Re: 1500 S. Chrisway Drive (Chrisway Townhouses)

This office is in receipt of preliminary architectural drawings and a letter of explanation providing details for a proposed parcel subdivision and townhouse development at 1500 S. Chrisway Drive. The proposal includes demolition of the existing single-story, single-family home and replacing it with two each 2-story duplex townhouse buildings with a single car garage and driveway at each unit. A project vicinity map is provided as Exhibit A and the conceptual architectural site plan is provided as Exhibit B.

EXHIBIT B

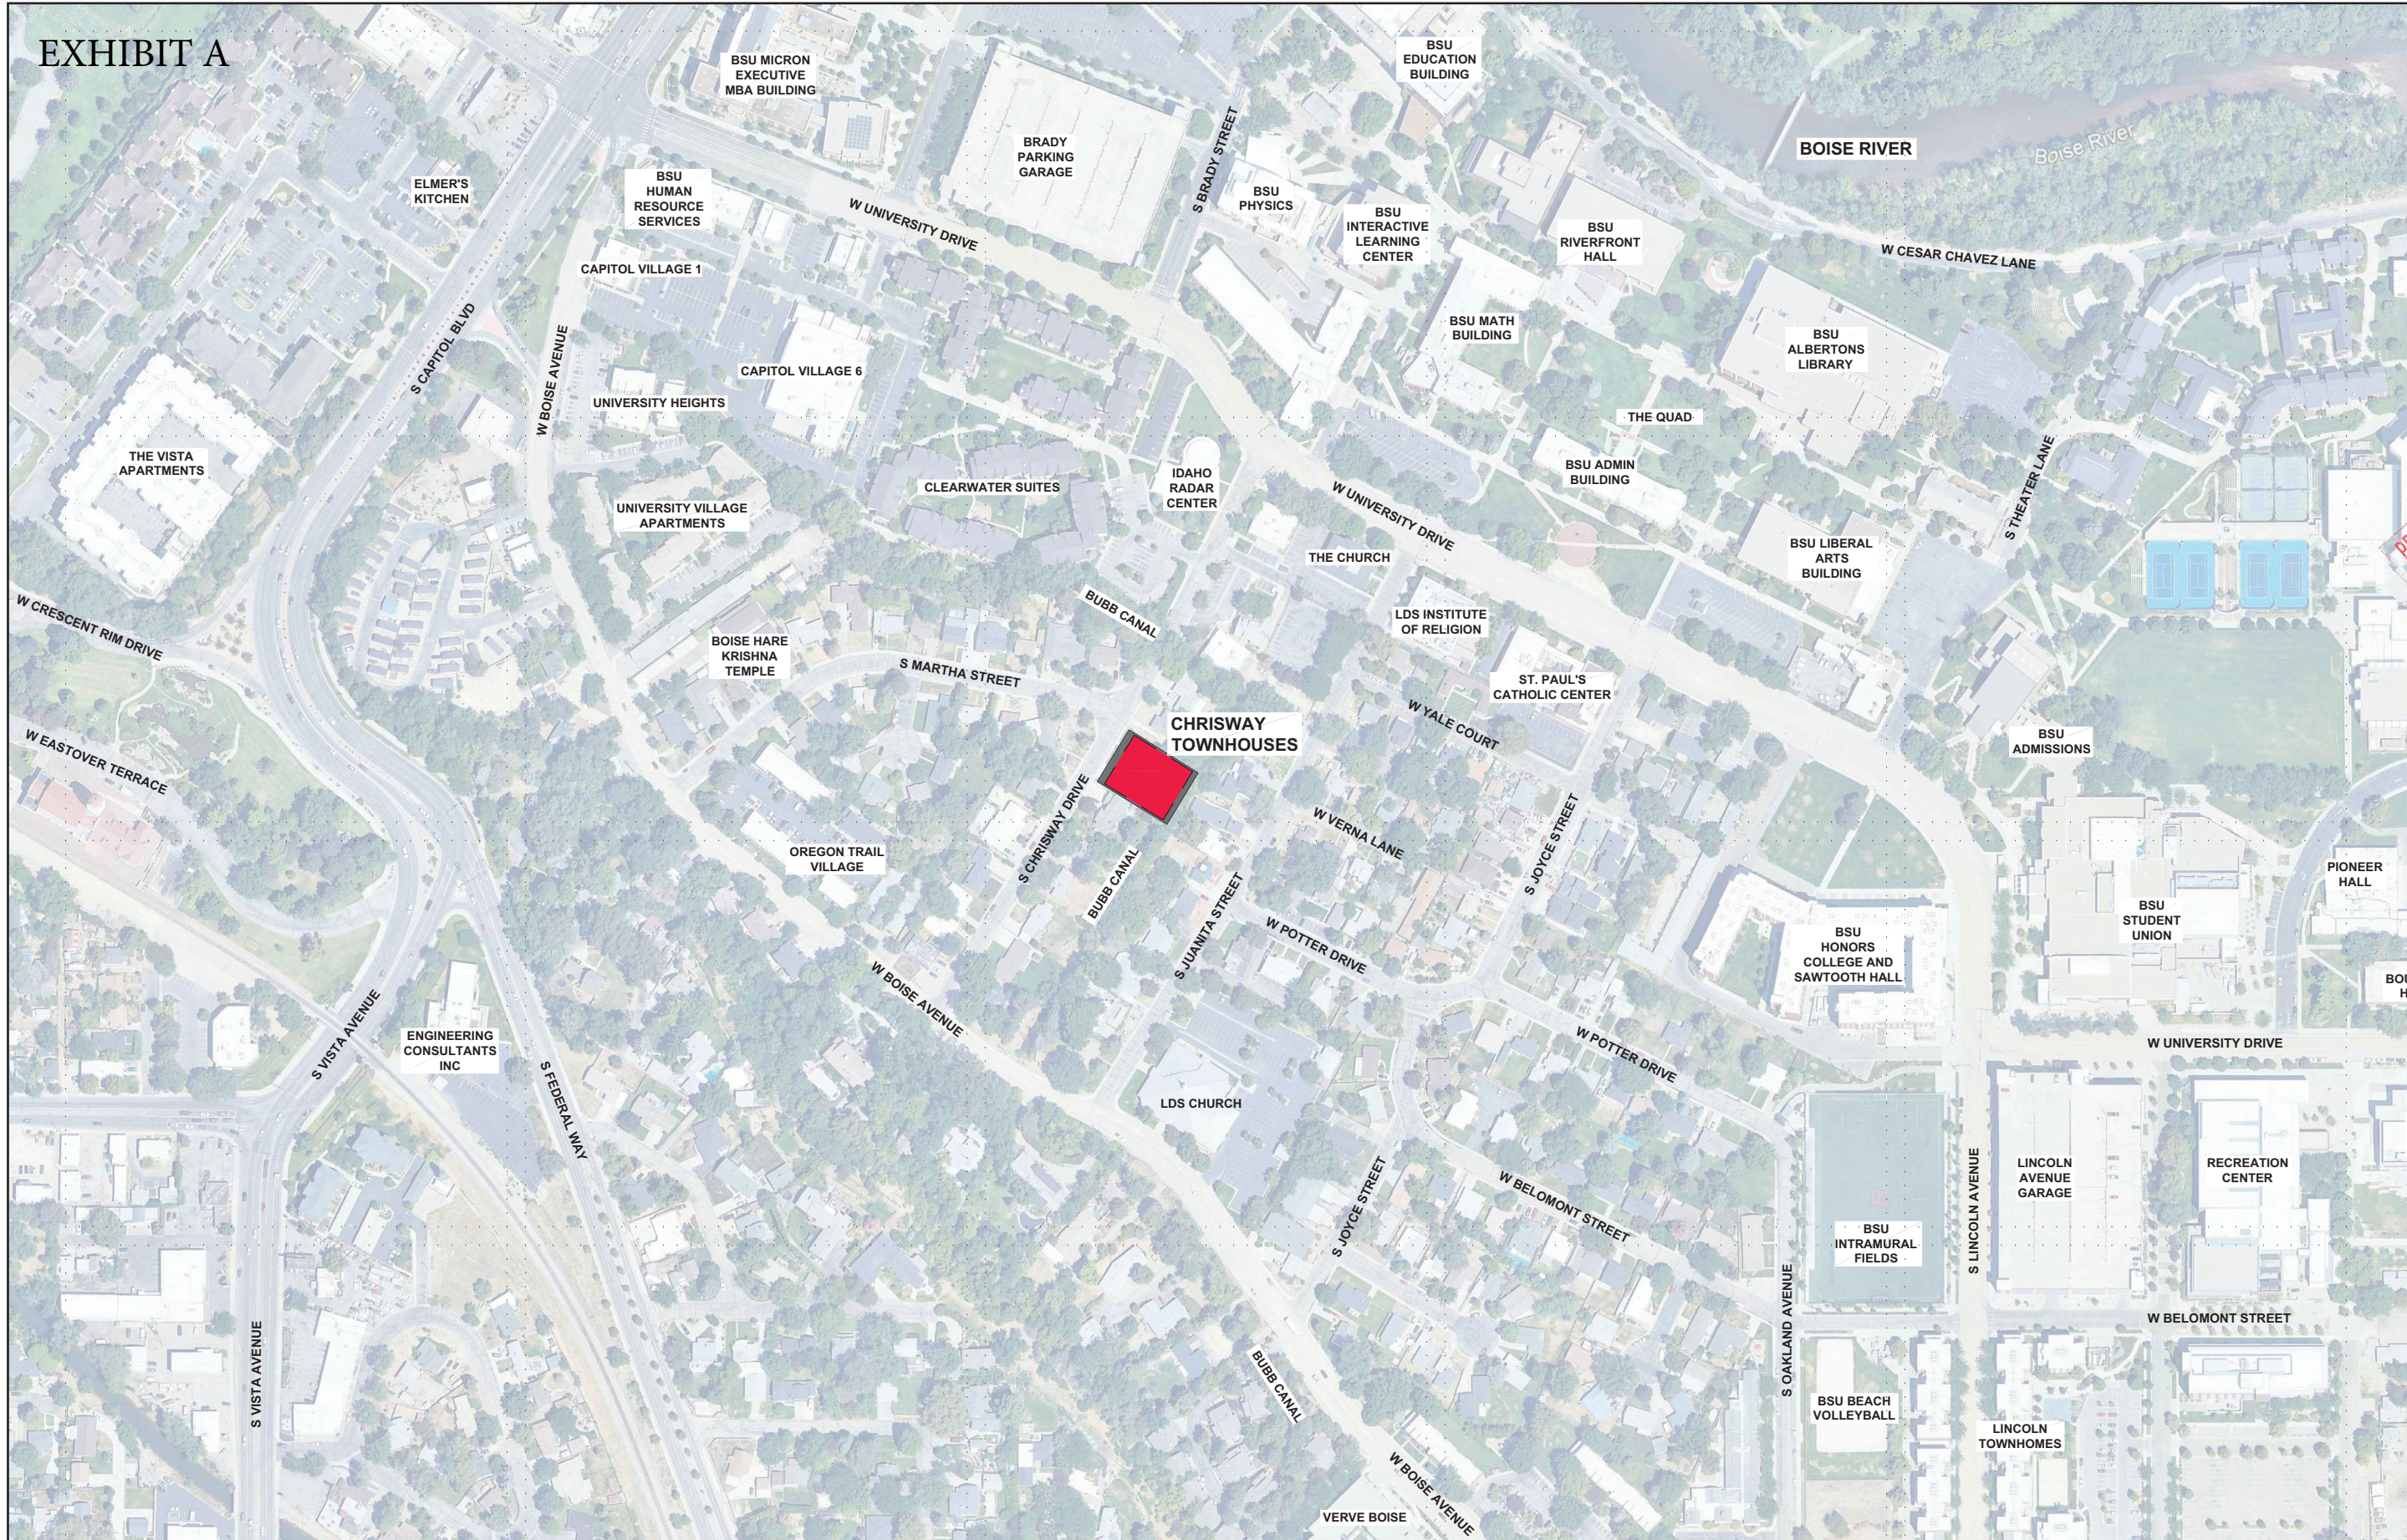
Exhibit B depicts a top of bank line (labeled TOP) for the Drain and includes a dimension from the top of bank to the nearest townhome showing a distance of 48'-6". Exhibit A also depicts an approximately 10-foot-wide covered patio at the rear of each townhome. Based on the scale provided on Exhibit A, we estimate that the distance from the centerline of the Drain to the nearest covered patio is approximately 48 feet.

Based on the information depicted on Exhibit A, it is apparent that the proposed building improvements are entirely situated outside of the Drain easement. However, several large trees are proposed to be planted in the easement and are shown to be at least 30 feet from the nearest top of bank of the Drain. Further review of the provided documents indicates that the Applicant intends to leave the Drain in its current condition. I found no reference to site drainage facilities in the preliminary drawings. However, the letter of explanation states that "All stormwater that falls on the site after improvements shall be collected, stored, and disposed of within the project parcel boundaries."

1. The current proposal depicts all building improvements being constructed outside of the existing Drain easement but does depict several trees being planted within the easement. The license

agreement should clarify the respective responsibilities of the Drainage District and the Applicant with respect to long-term maintenance or other potential liability due to the presence of the proposed trees within the easement.

2. Site drainage is indicated as being retained on-site. The applicant should provide engineering drawings demonstrating the overall site grading and drainage plan to provide assurance that all stormwater will be retained on-site without discharge to the Drain.

Based on the above findings, I recommend that the Board initiate the process of entering into a license agreement with the Applicant to ensure that the Drainage District's long-term interests are protected as the project progresses, specifically with respect to the following:
